# **EXHIBIT D-1**

## **DRAWINGS AV0001 – AV6103**

**RFP No. 901516 – East County Hall  
of Justice BDA & DAS**

EAST COUNTY HALL OF JUSTICE

DRAWING TITLE	LEVEL 4 AV FACILITIES RCP
- AREA A	
PROJECT #	20130014.001
OSPM: 01-01-11-0005	
SHEET NUMBER	AV3141

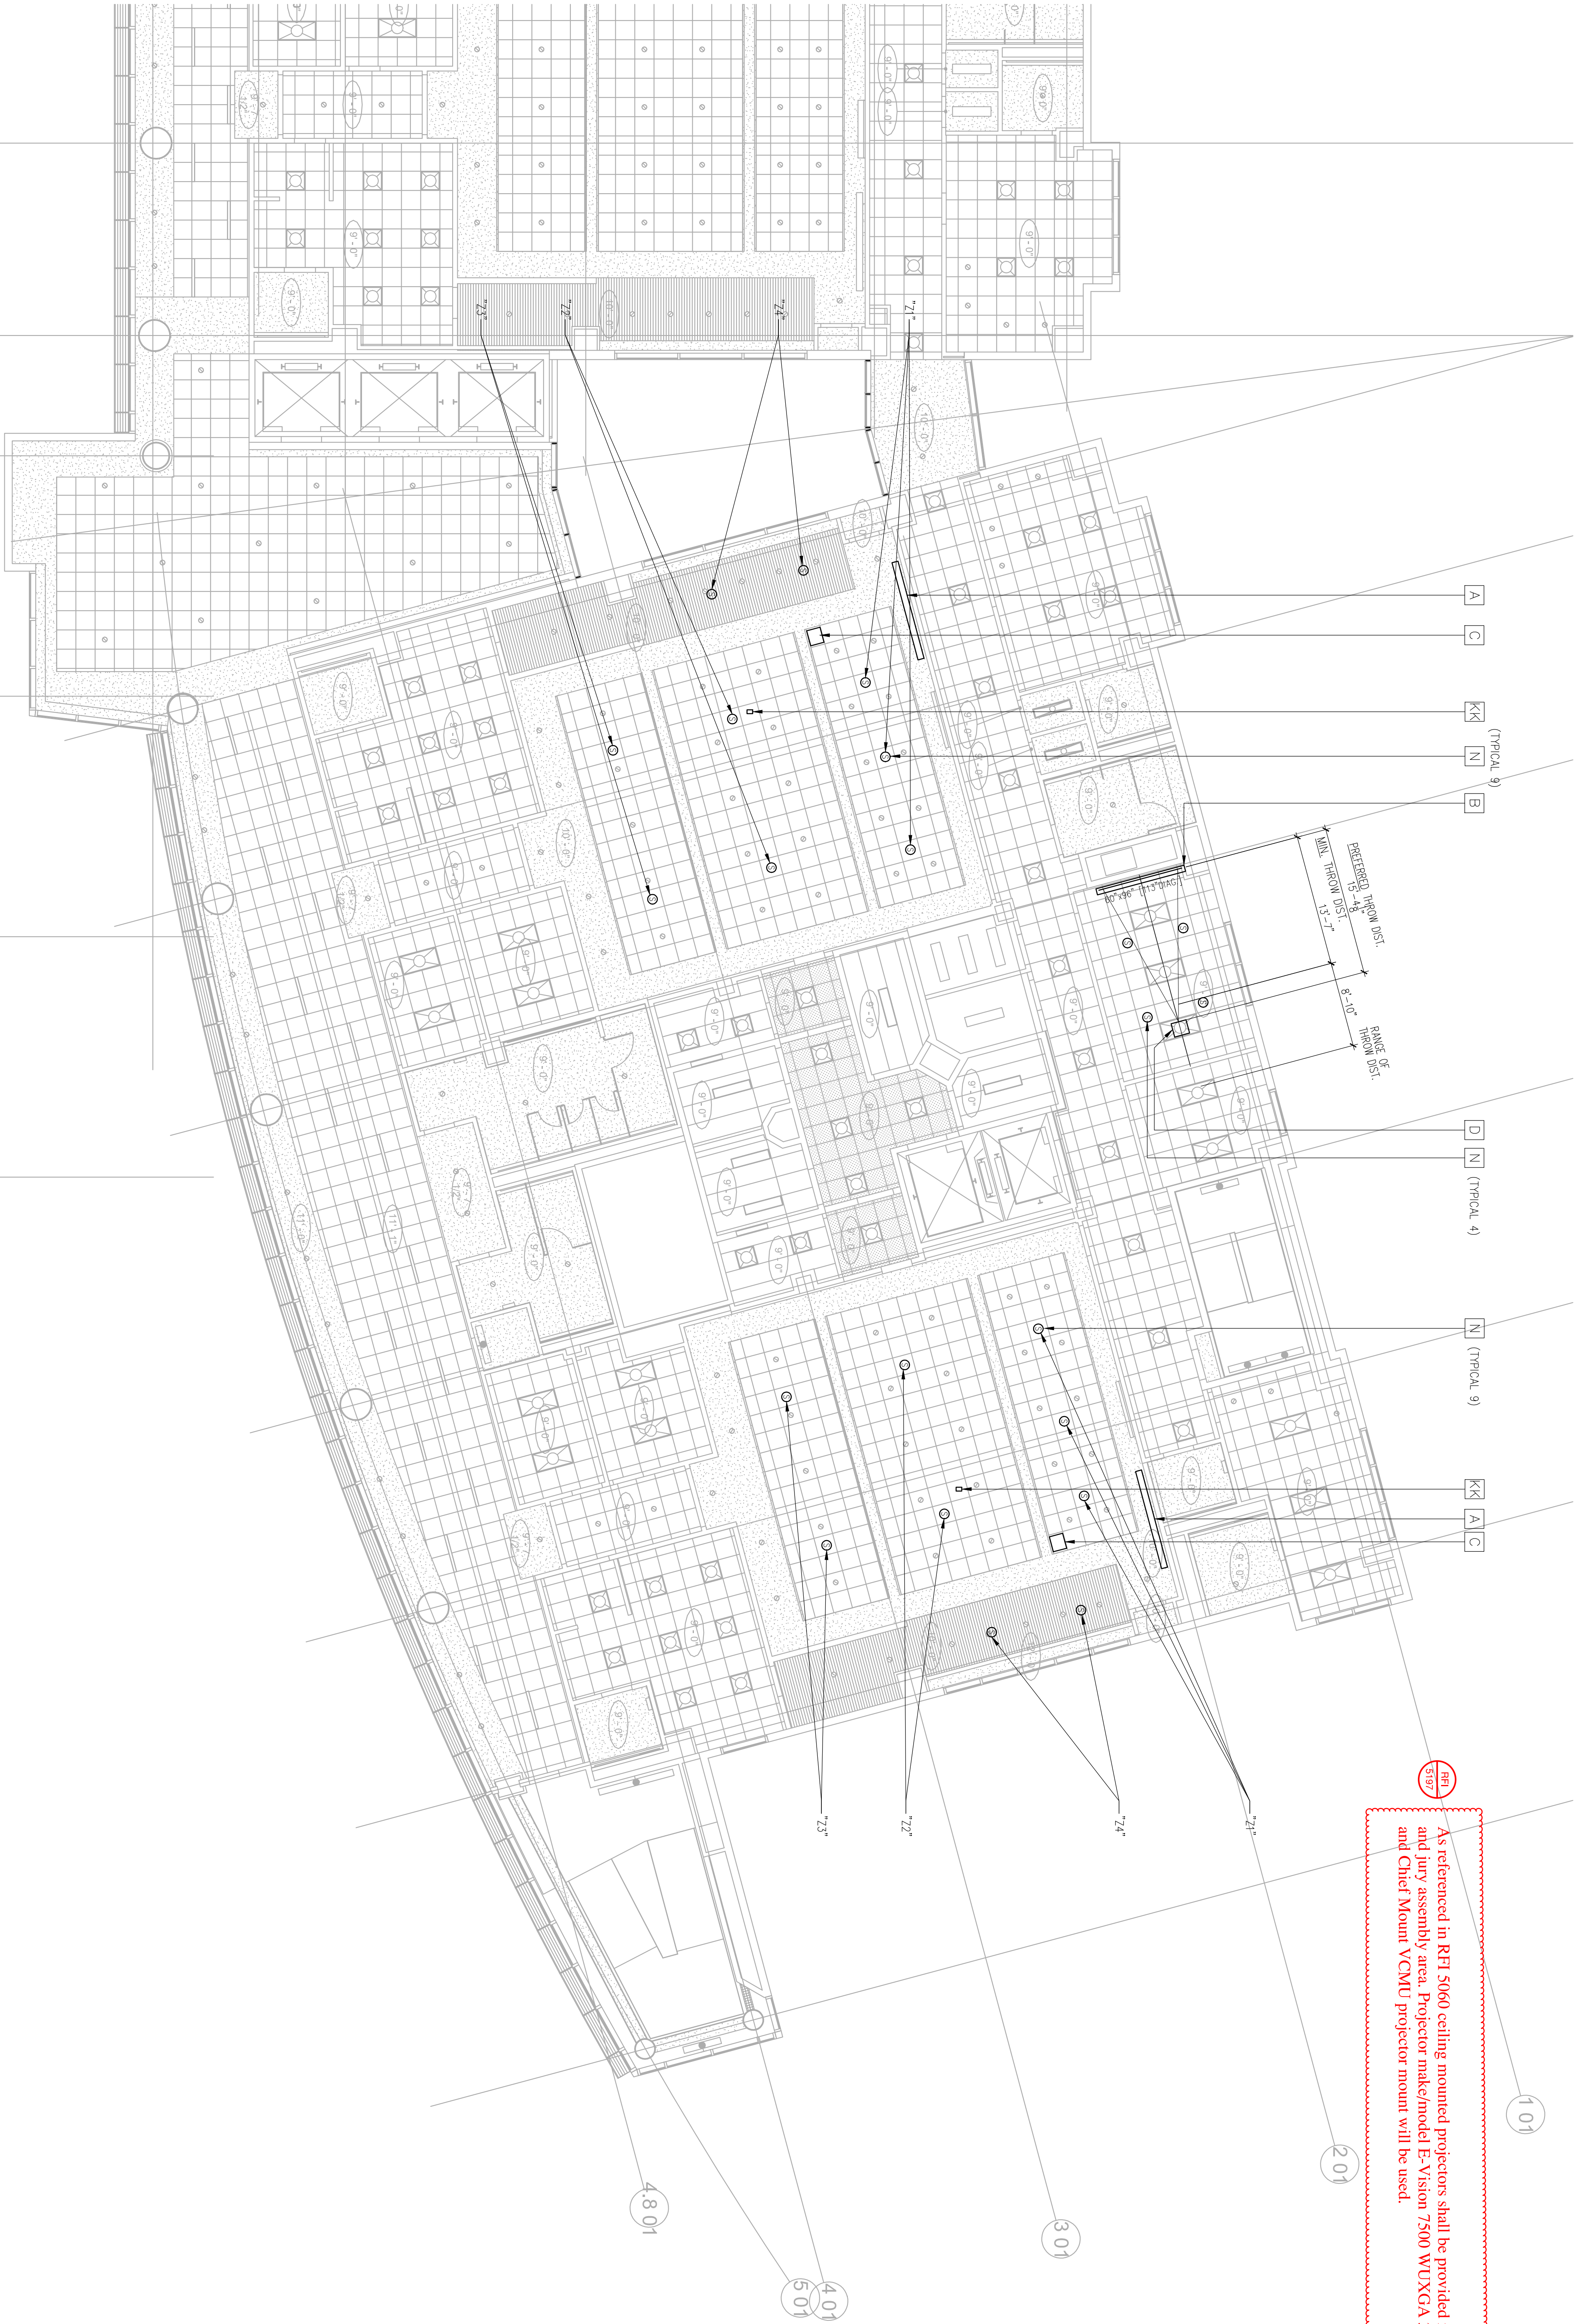
As referenced in RFI 5060 ceiling mounted projectors shall be provided in all 13 courtrooms and jury assembly area. Projector make/model E-Vision 7500 WUXGA 3D Digital Projector and Chief Mount VCMU projector mount will be used.

AV3142

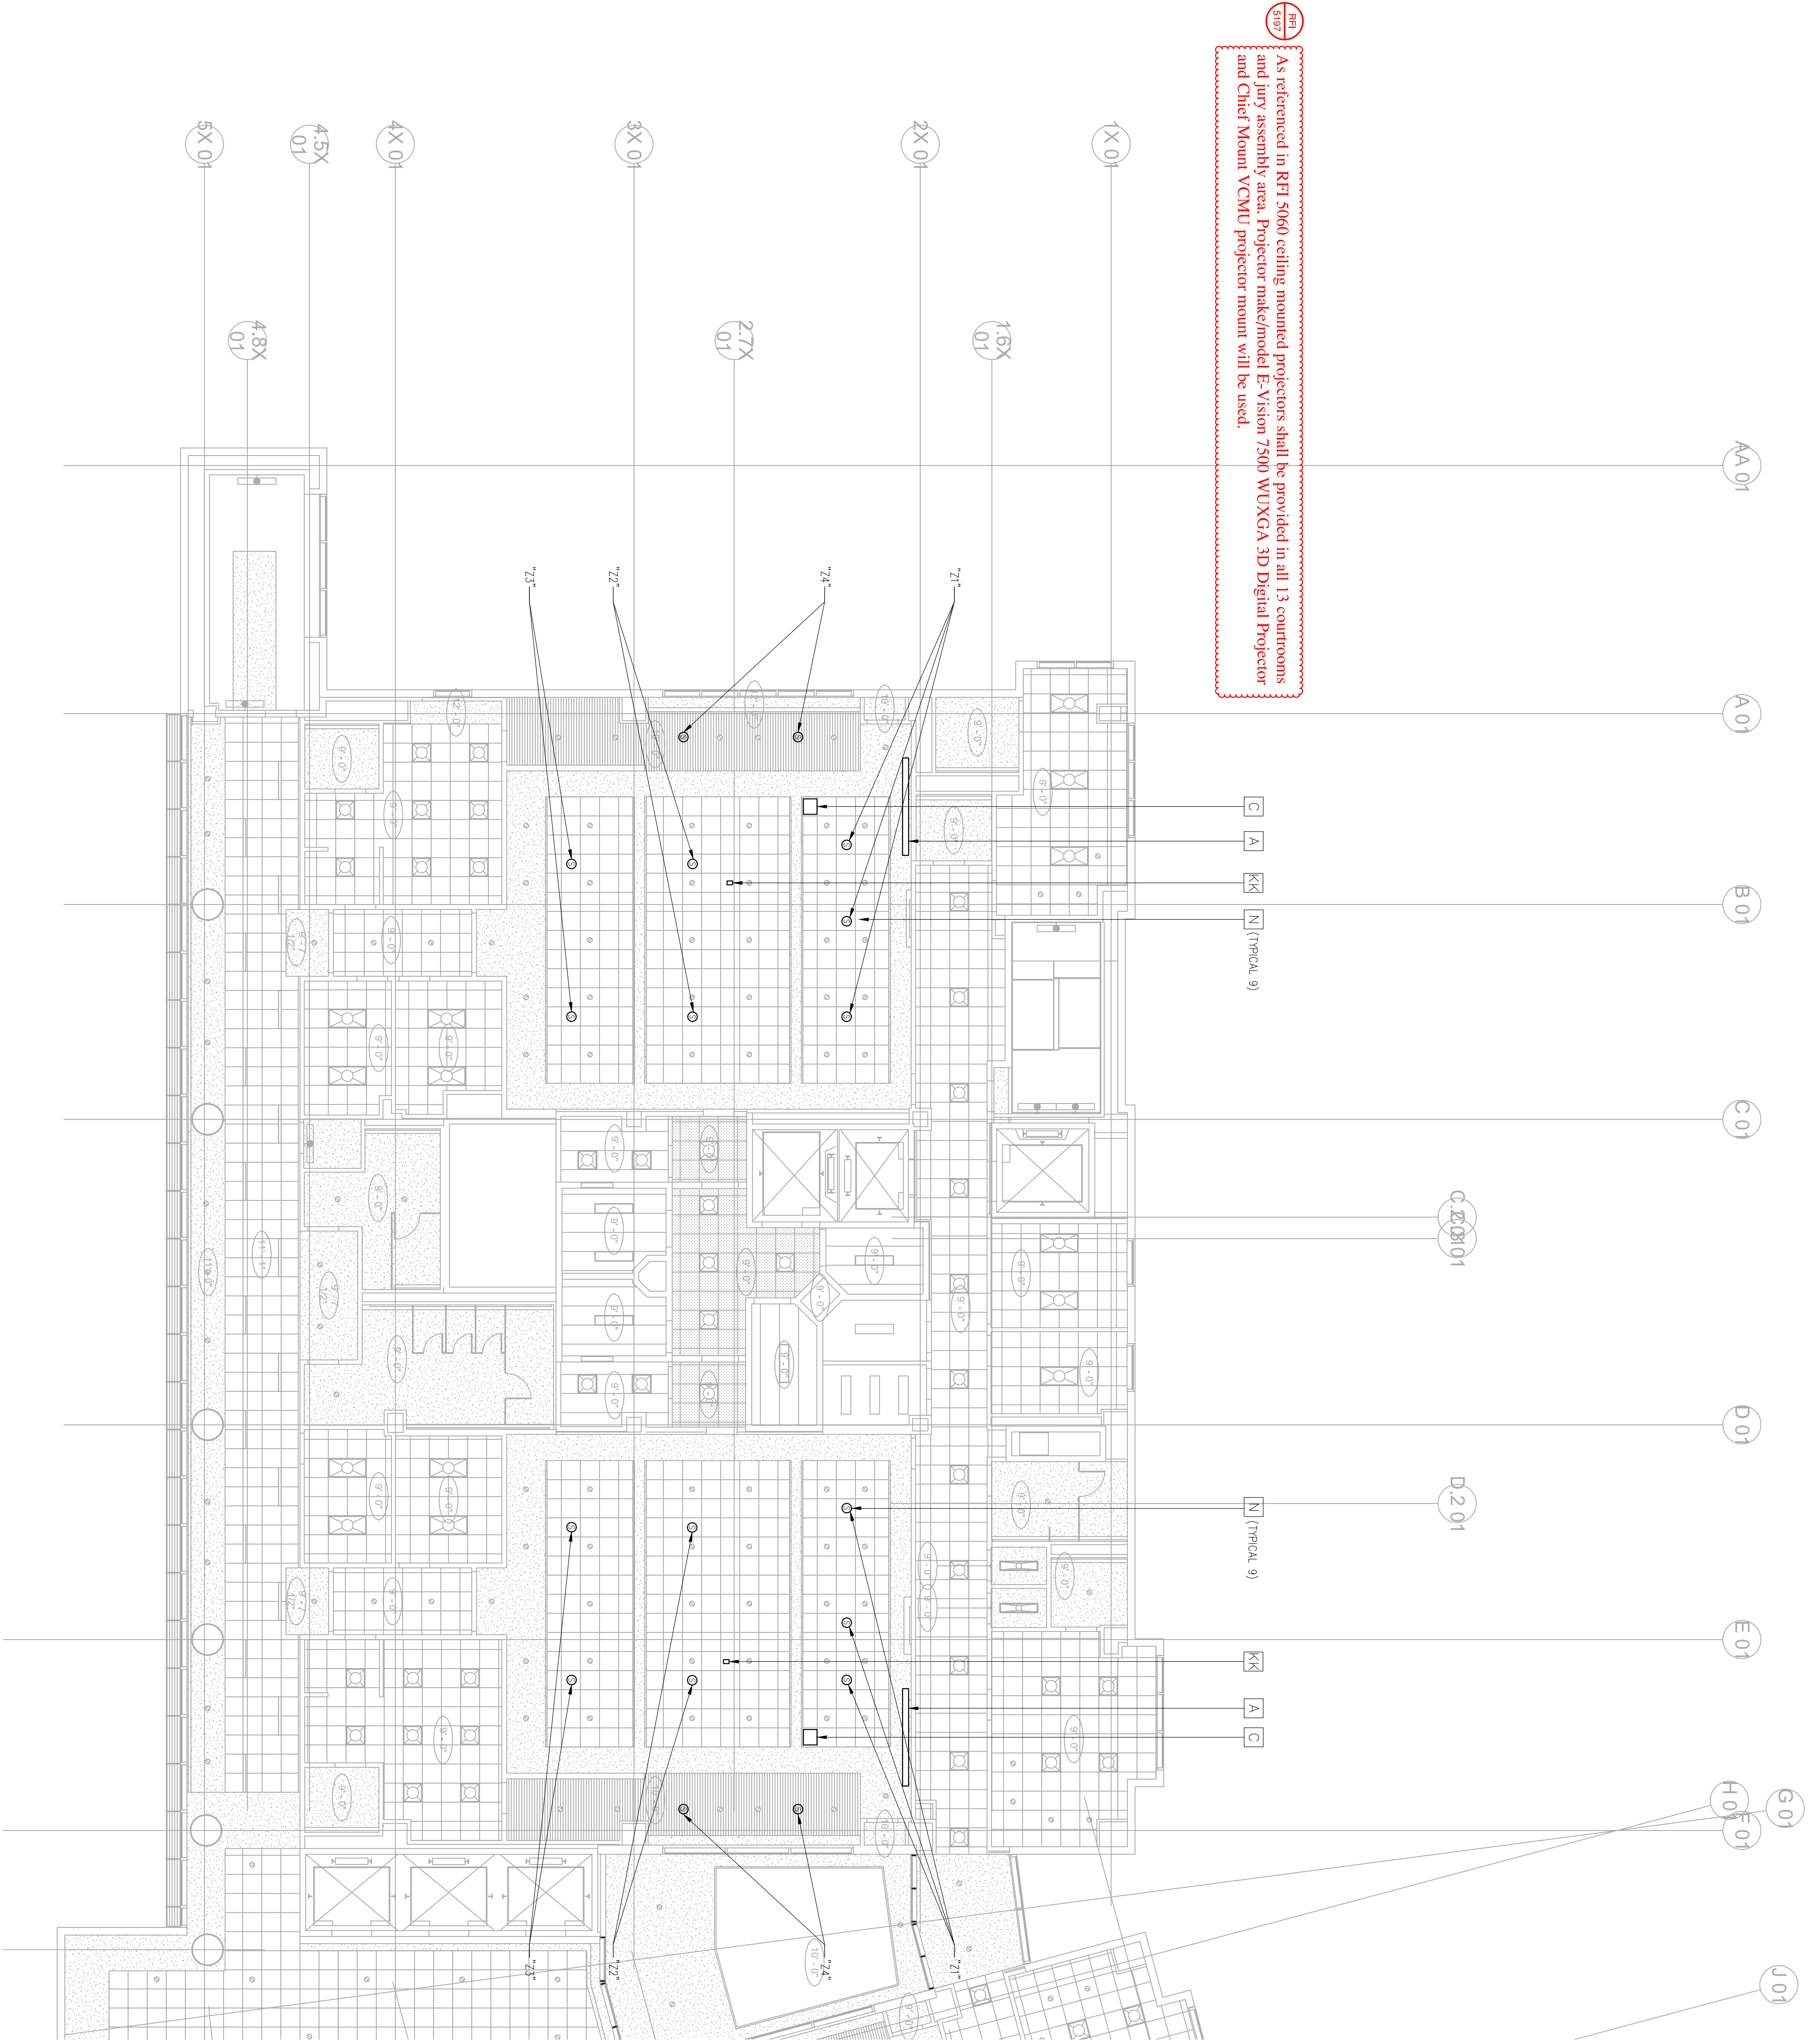
As referenced in RFI 5060 ceiling mounted projectors shall be provided in all 13 courtrooms and jury assembly area. Projector make/model E-Vision 7500 WUXGA 3D Digital Projector and Chief Mount VCMU projector mount will be used.

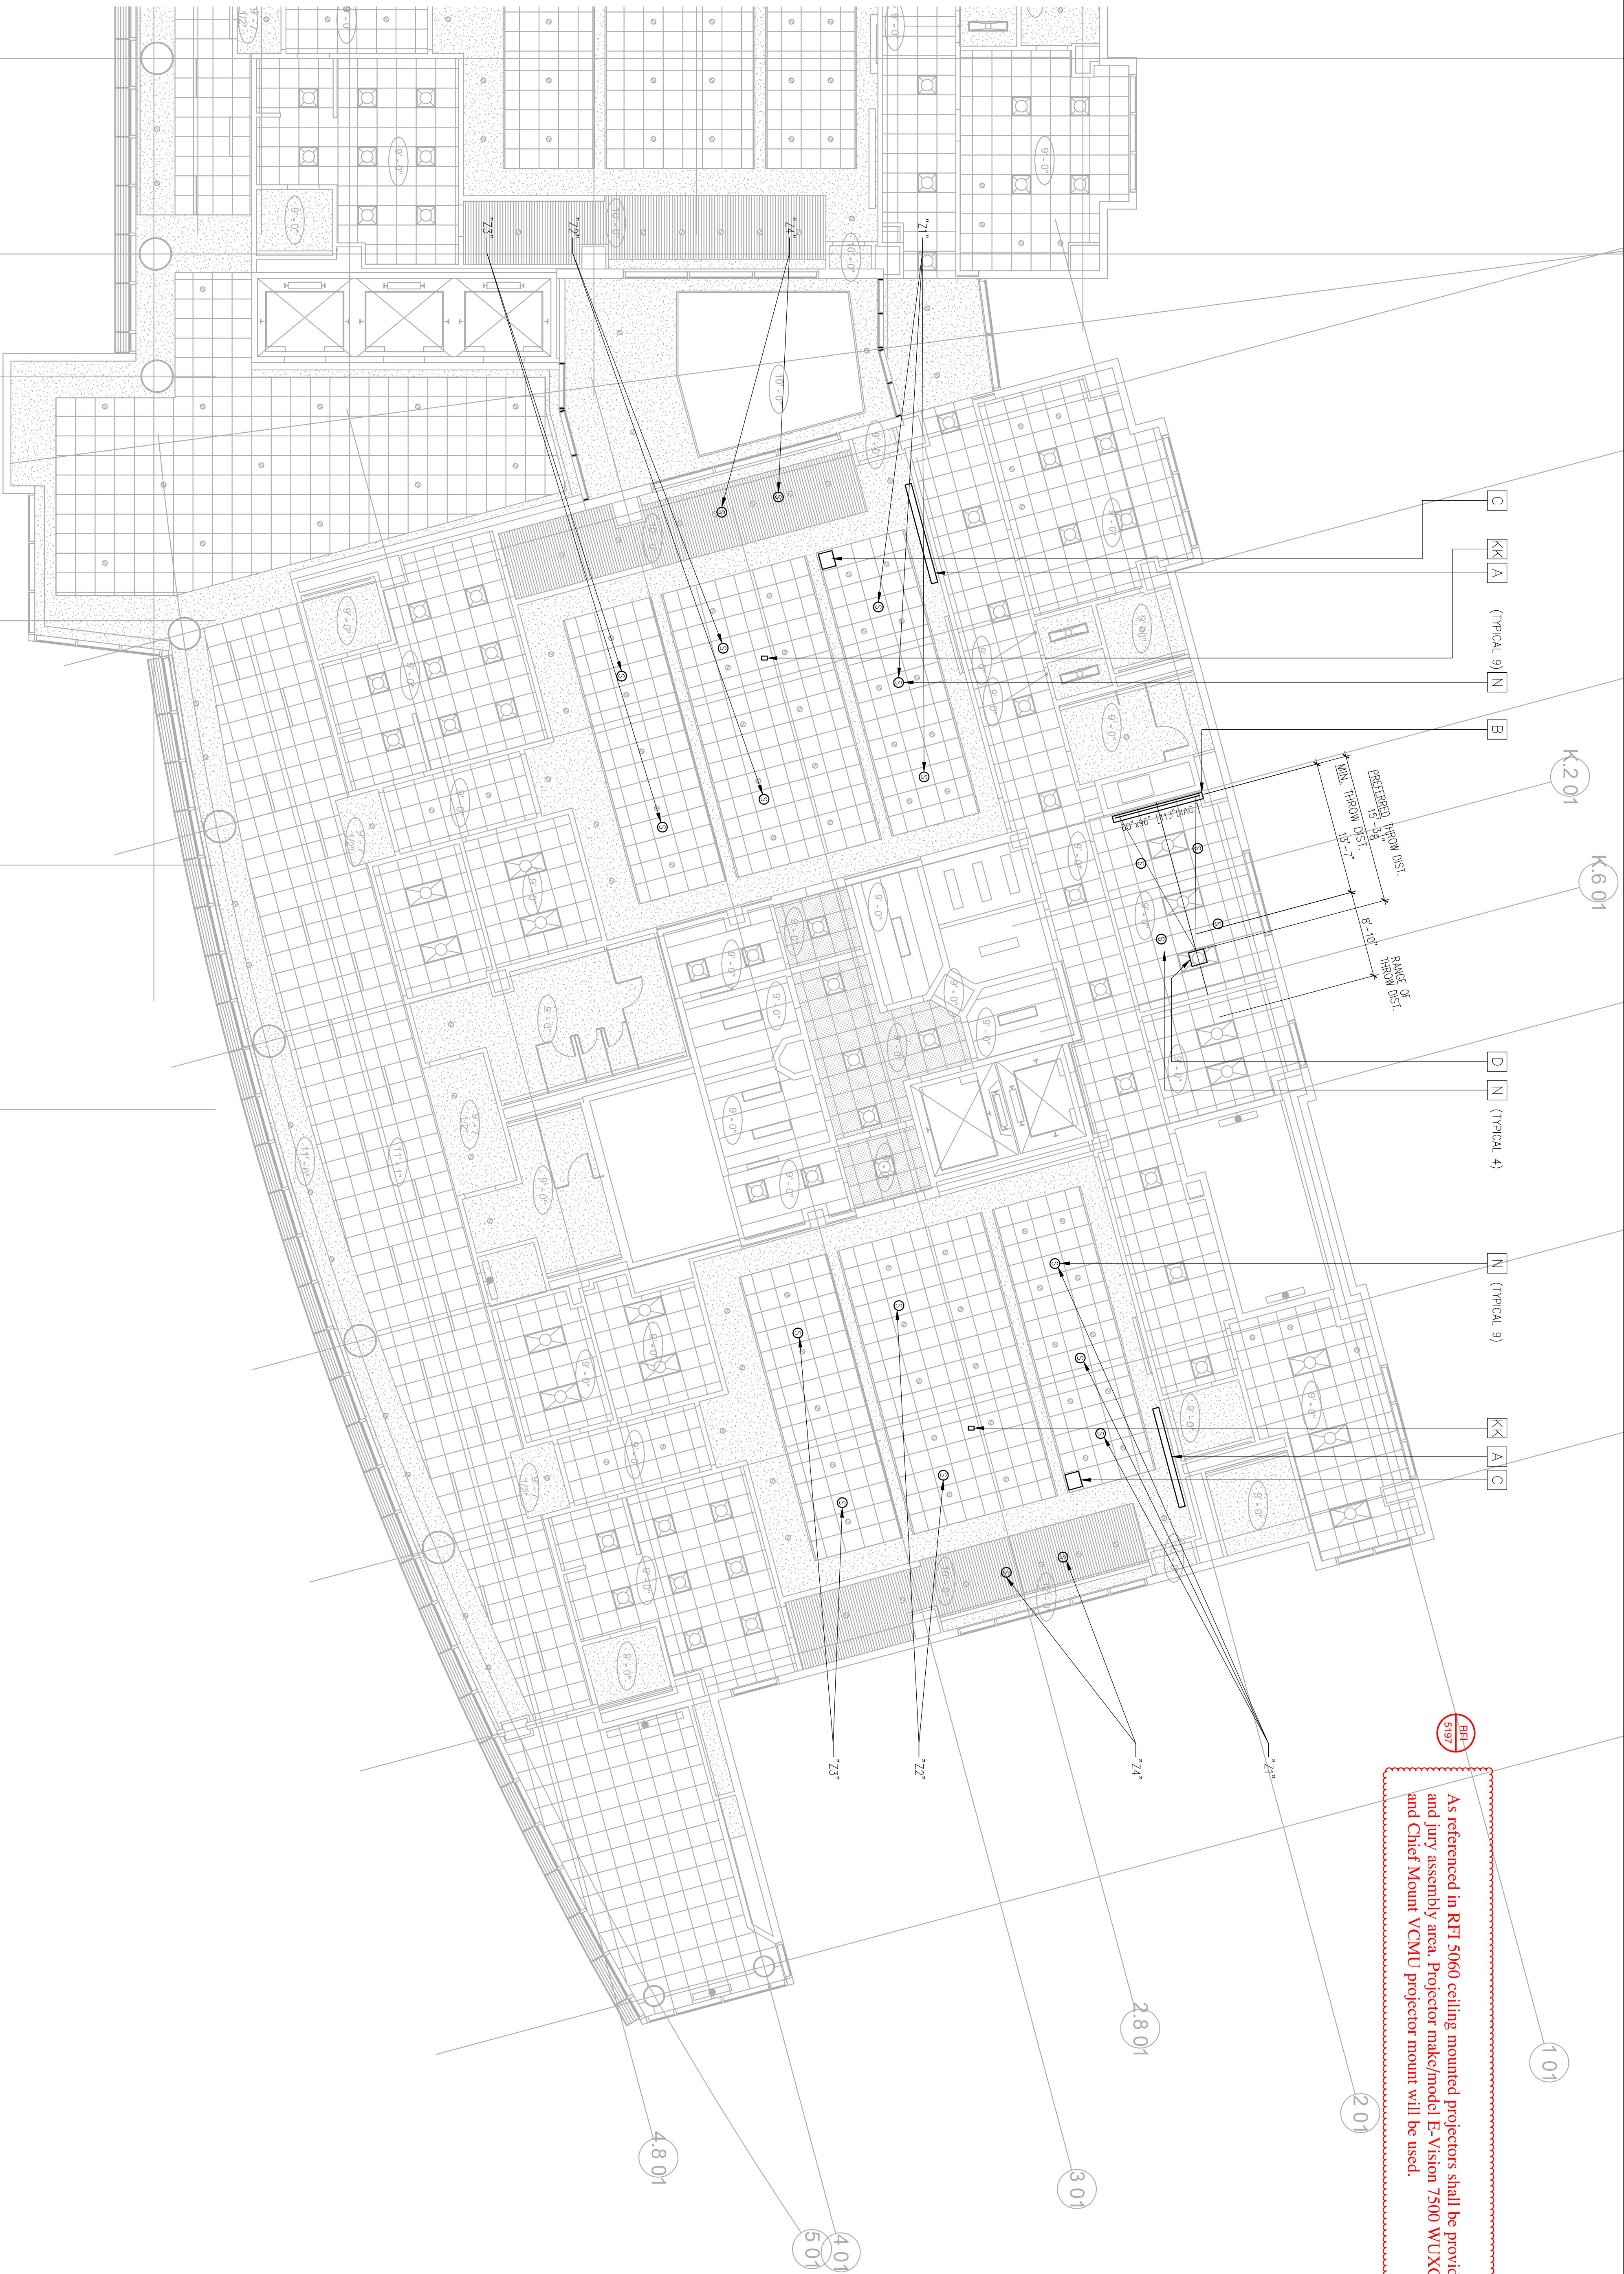
As referenced in RFI 5060 ceiling mounted projectors shall be provided in all 13 courtrooms and jury assembly area. Projector make/model E-Vision 7500 WUXGA 3D Digital Projector and Chief Mount VCMU projector mount will be used.
